Executive Director's Recommendation

Commission Meeting: July 12, 2018

PROJECT Joint Base Andrews Consolidated Communications Center Joint Base Andrews Camp Springs, MD	NCPC FILE NUMBER 7902
	NCPC MAP FILE NUMBER 3207.00(38.00)44780
SUBMITTED BY United States Department of Defense Department of the Navy	APPLICANT'S REQUEST Approval of preliminary site and building plans
REVIEW AUTHORITY Federal Projects in the Environs per 40 U.S.C. § 8722(b)(1)	PROPOSED ACTION Approve of preliminary site and building plans with comments
	ACTION ITEM TYPE Staff Presentation

New Consolidated Communications Center (P-3003)

2017 Concept / 2018 Preliminary Plan Comparison

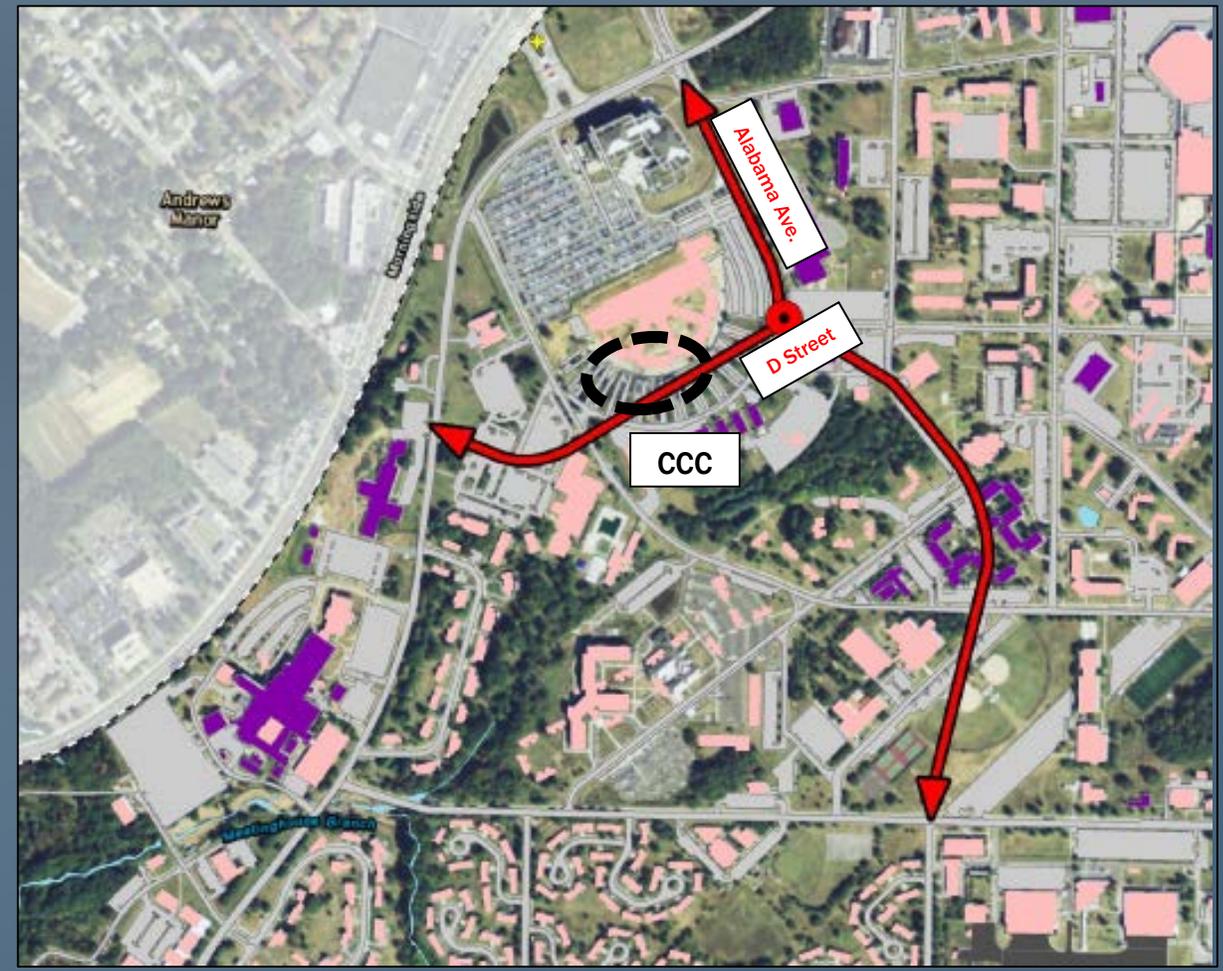
1. arched-road maintained
2. surface parking areas maintained (-30 fewer spaces)
3. smaller building (-19,310 SF)

4. drop-off area (transit)
5. bike rack (10-bike capacity)
6. AT-FP stand-off distance maintained
7. on-site access/circulation

Planning Considerations – Center street-building orientation

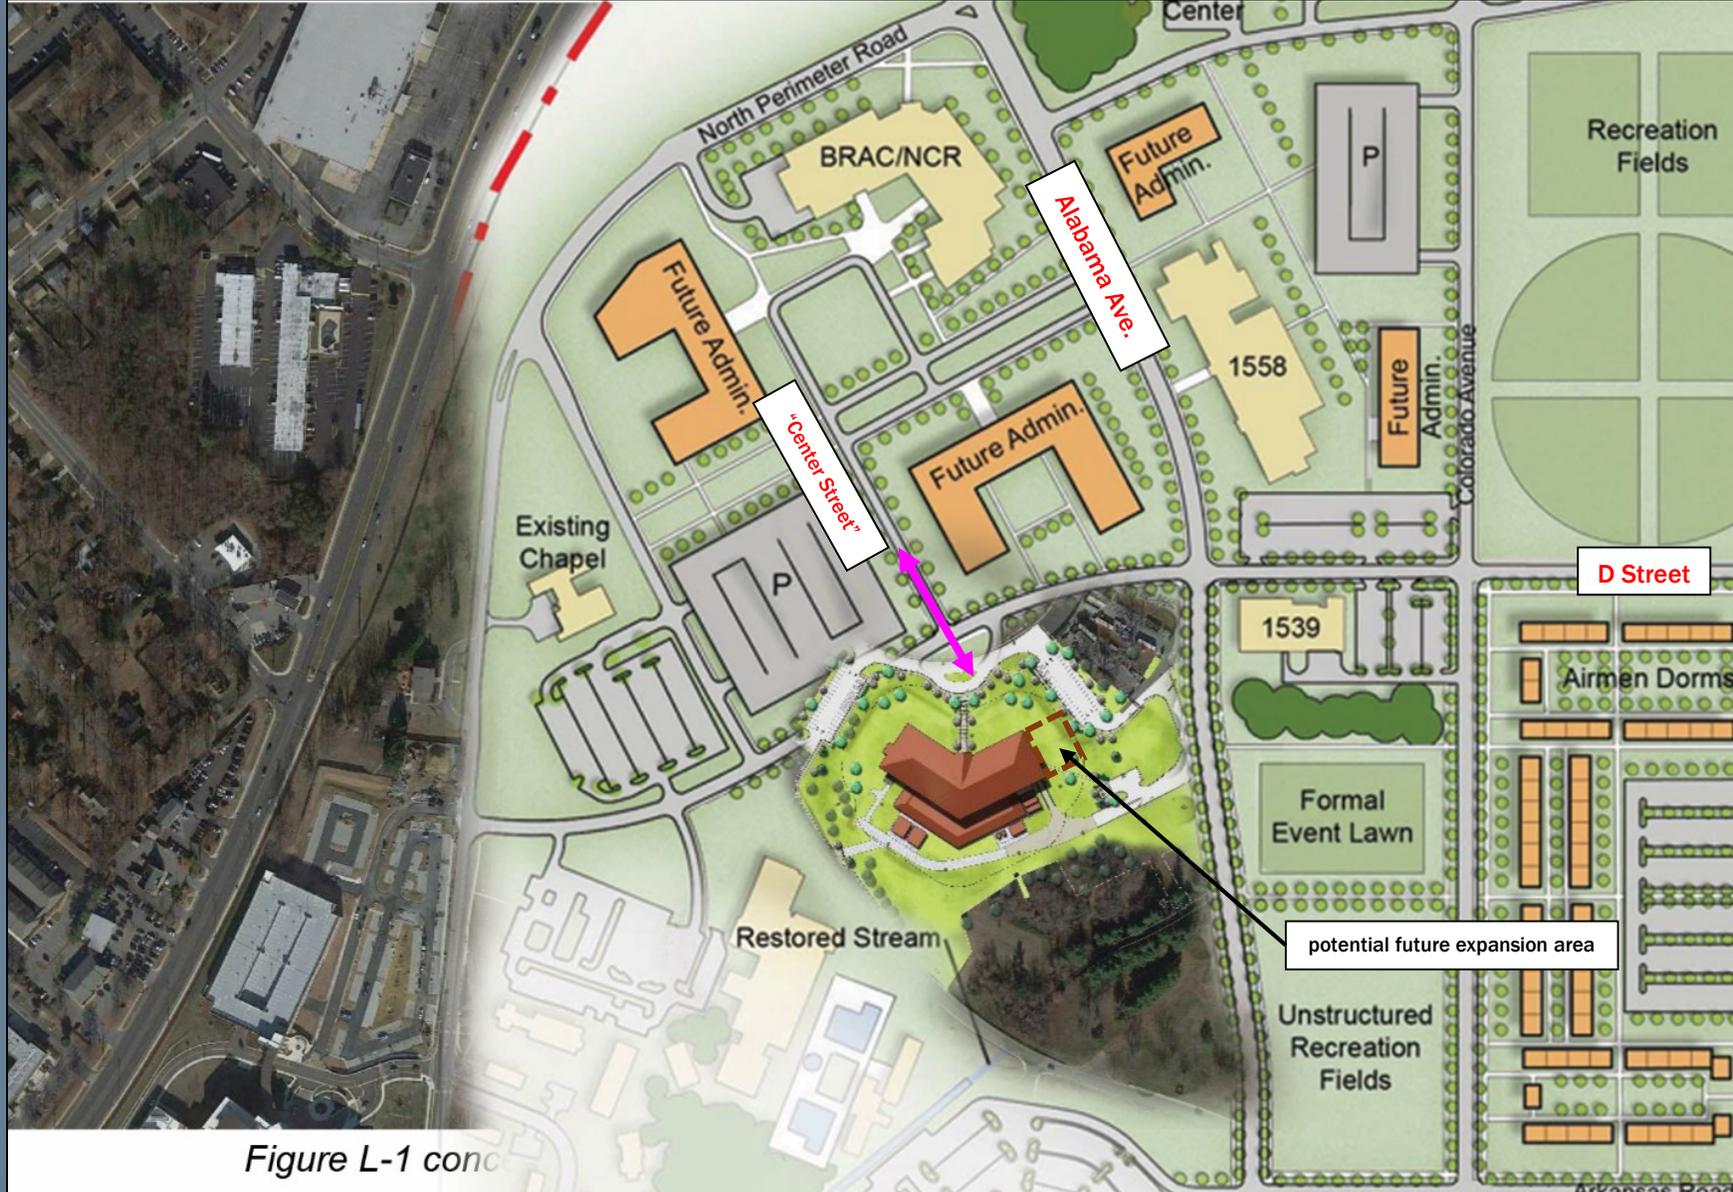
Finds the building's main entry, at its point of inflection, is not on-axis with the center street due to site limitations and the need to utilize existing roads and parking in the interim for cost savings.

Given the design constraints (88-foot AT/FP buffer, preserving as much existing paved area as possible for parking and circulation) and future intended non-public use of the future CCC, its main entrance (at the building's point of inflection) is not on-axis with the center street. Therefore, staff recommends that the Commission **find the building's main entry, at its point of inflection, is not on-axis with the center street due to site limitations and the need to utilize existing roads and parking in the interim for cost savings.**

Planning Considerations – D Street-building orientation

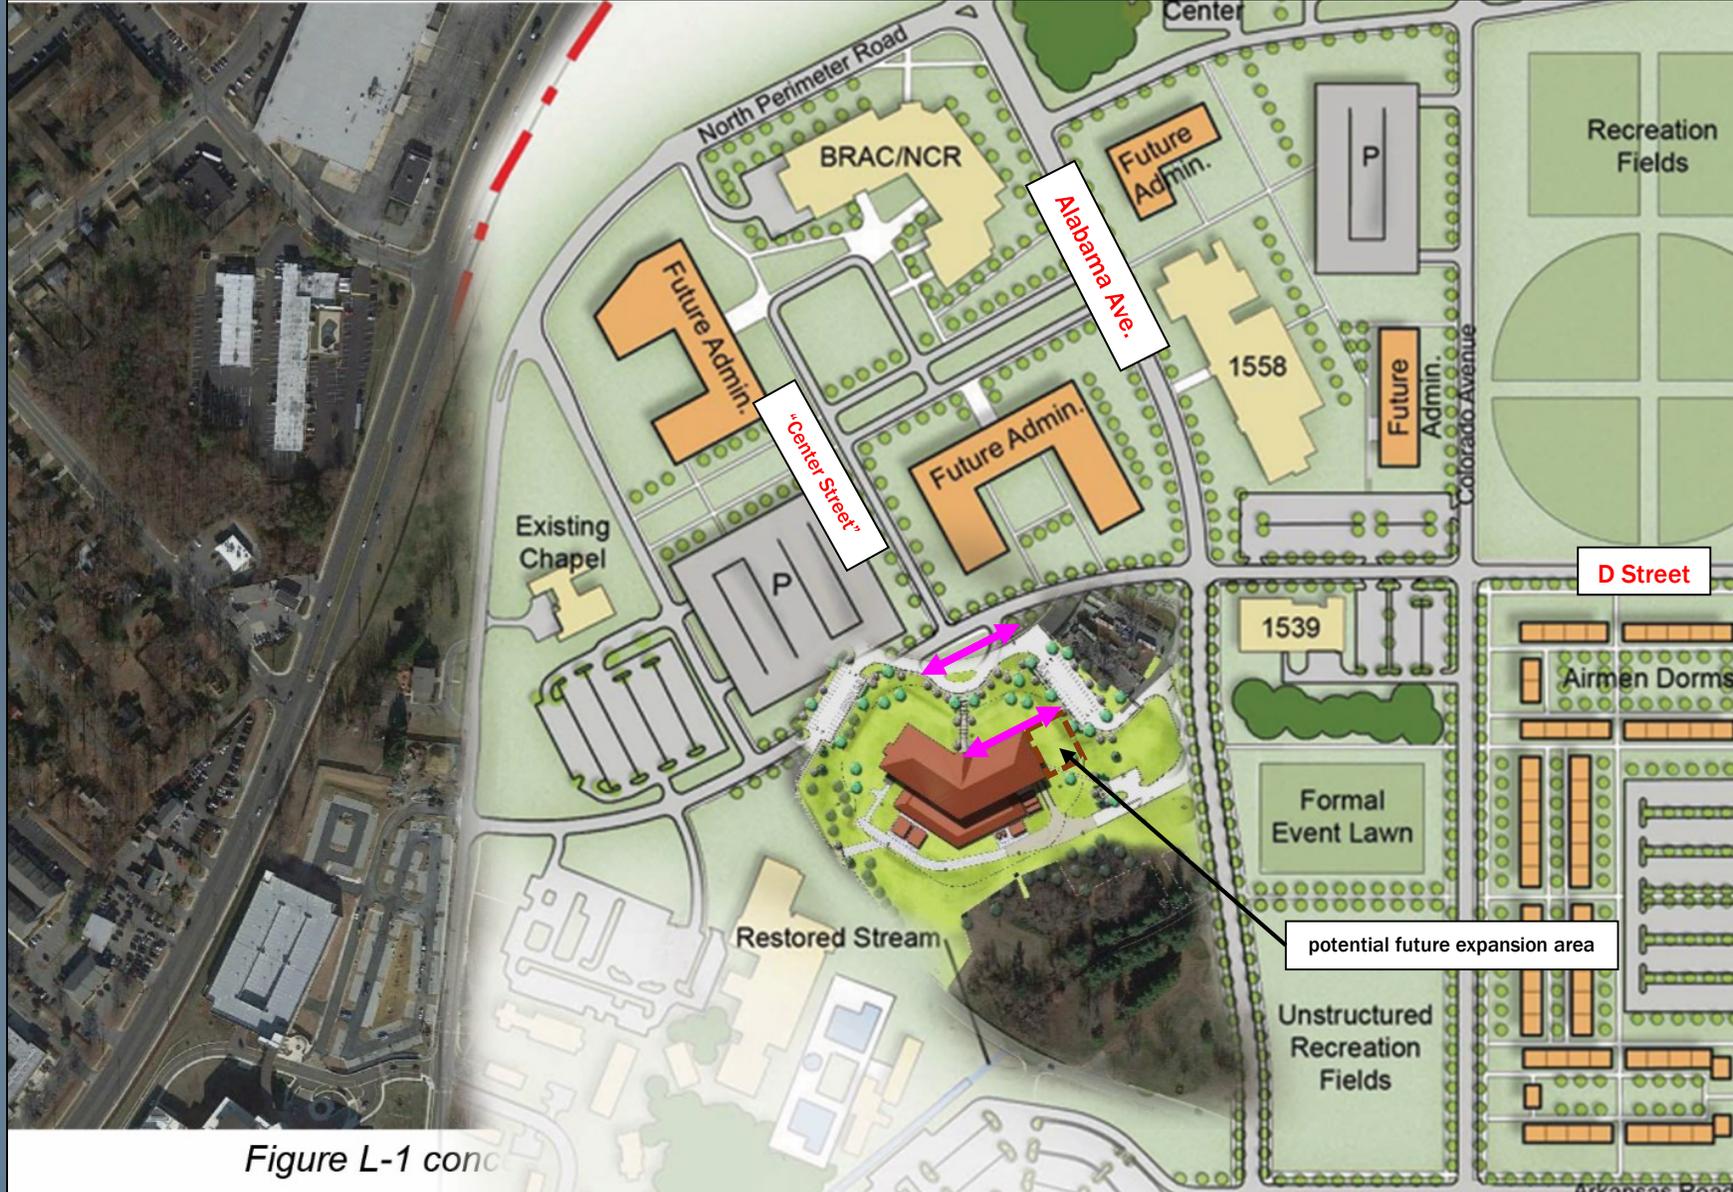
Requests that the Navy maintain the proposed orientation of the east wing/future expansion (approximately parallel to the D Street expansion) and the location of the driveway at the terminus of the proposed center street to support the street grid/development framework for the Administration and Support District.

To support the District's future street grid/development framework, the building's east wing (and future expansion area) should align with the future D Street extension to help define the future district edge. Furthermore, the location of the future CCC arched driveway should be situated at the terminus of the proposed center street to support the District's future street grid/development framework. Therefore, staff recommends that the Commission **request that the Navy maintain the proposed orientation of the east wing/future expansion (approximately parallel to the D Street expansion) and the location of the driveway at the terminus of the proposed center street to support the street grid/development framework for the Administration and Support District.**
